Town of Franklin

Planning Board

June 8, 2020

- 7:00 PM Commencement/General Business
- 7:05 PM <u>PUBLIC HEARING</u> Continued 176-210 Grove Street Site Plan

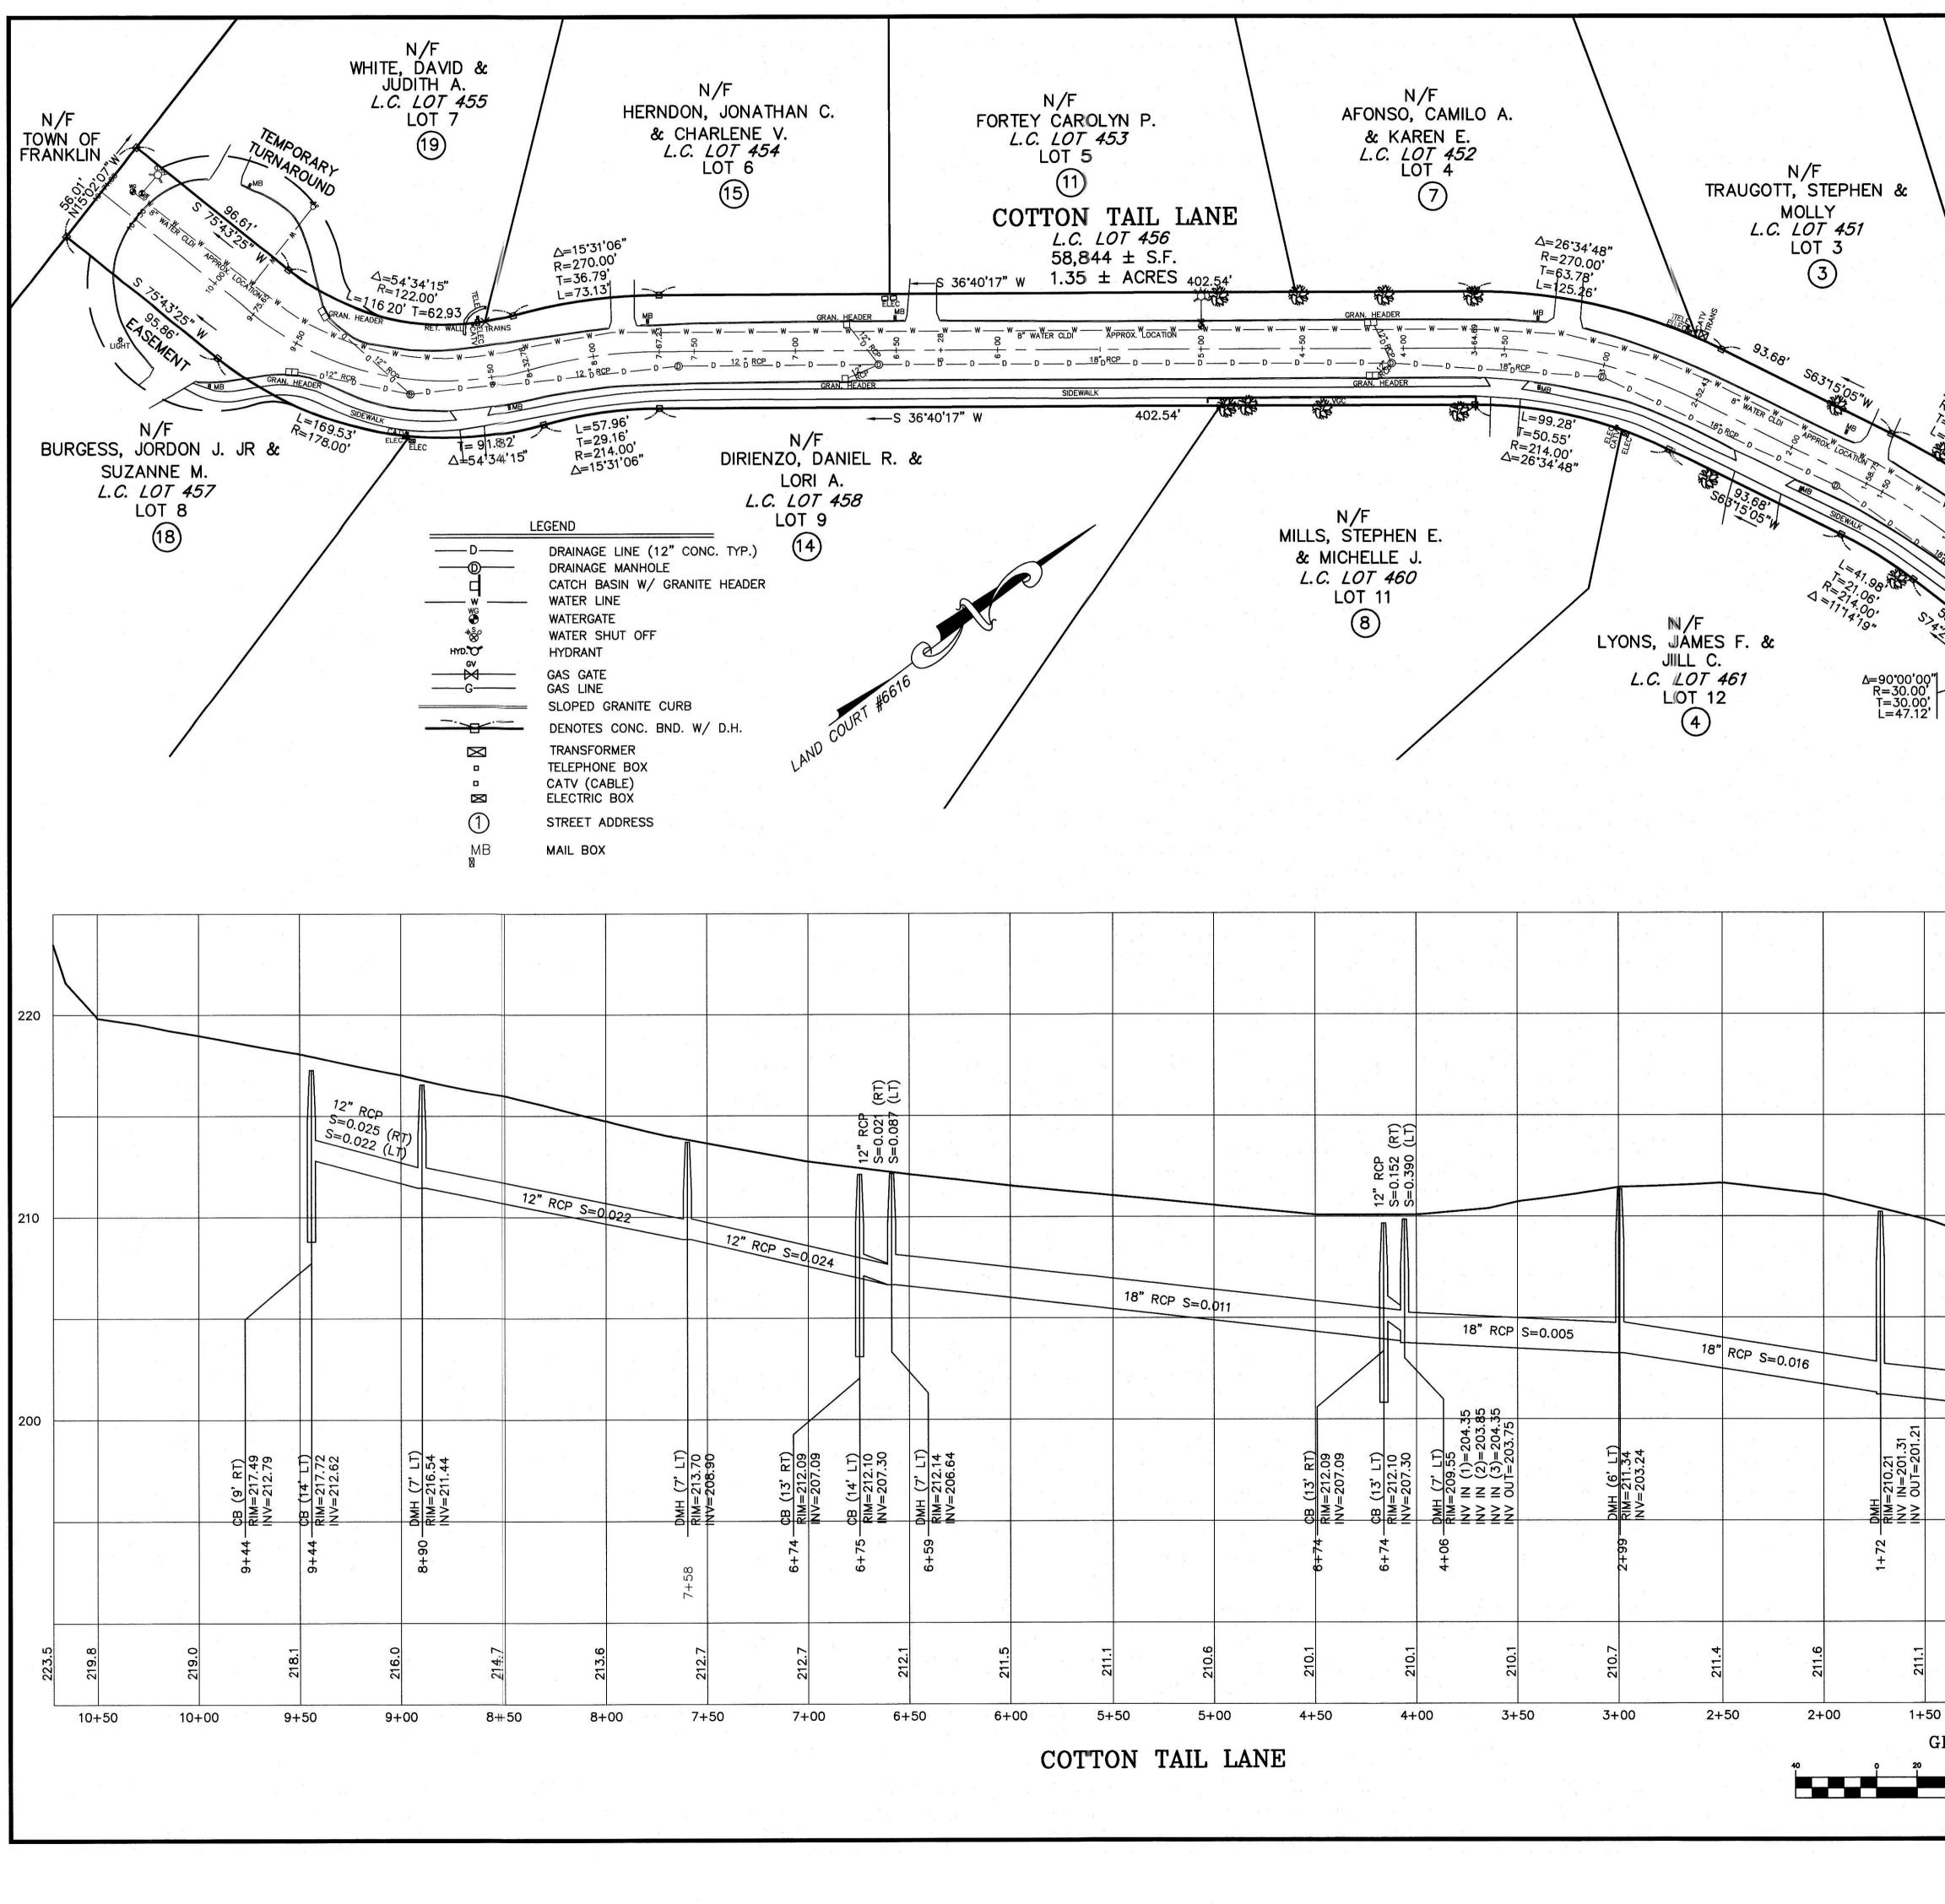
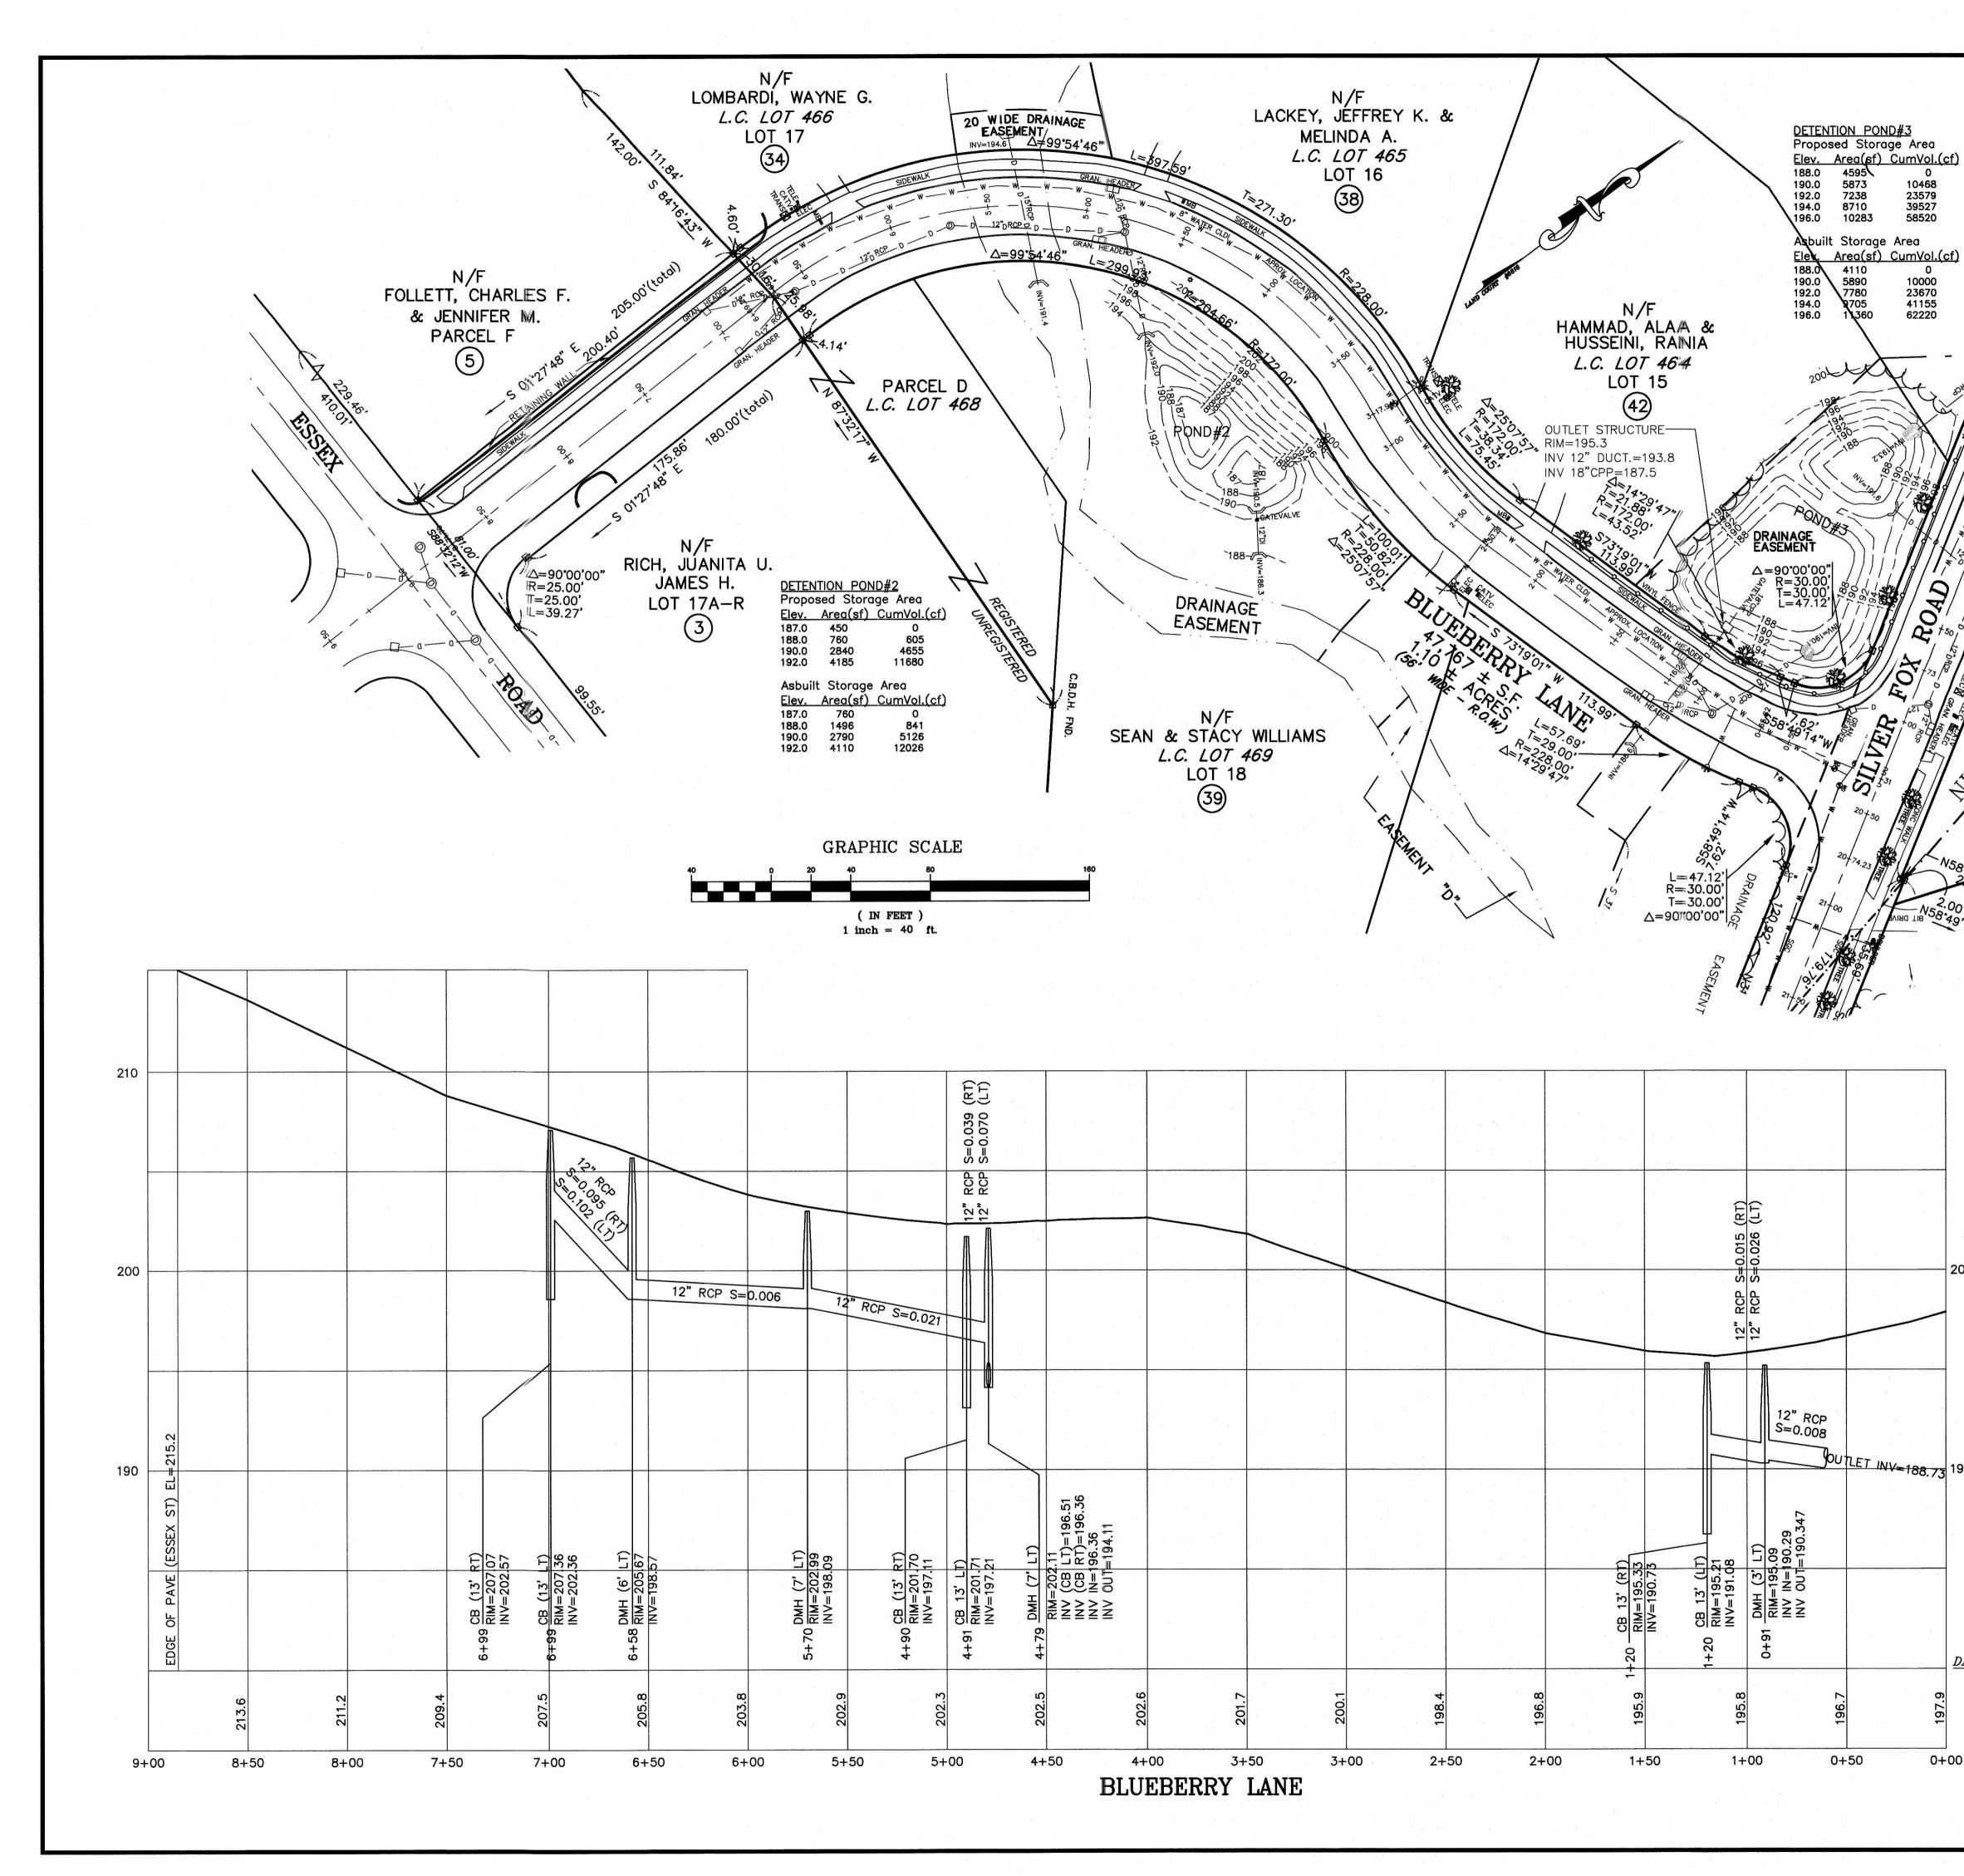
- 1. The Applicant has submitted Road Acceptance for the following streets:
 - a. Silver Fox 0+00-0+12 Bond Amount \$136,673
 - b. Cotton Tail 5+00-10+50 Bond Amount \$24,050
 - c. Blueberry Land 13+00-20+50 Bond Amount \$22,860
 - d. Cotton Tail 0+00-5+00 Bond Amount \$10,000
- 2. All necessary documentation has been submitted to the Town Attorney and Town Engineer for review.

- DPCD recommends releasing 3 out of 4 bonds.
 - Bonds to be release are \$136,673, \$24,050, \$22,860 = \$183,583
- DPCD recommends holding \$10,000 until streets are accepted by Town Counsel and recorded at the Registry of deeds.
- Planning Board will also need to vote to recommend street acceptance to the Town Counsel
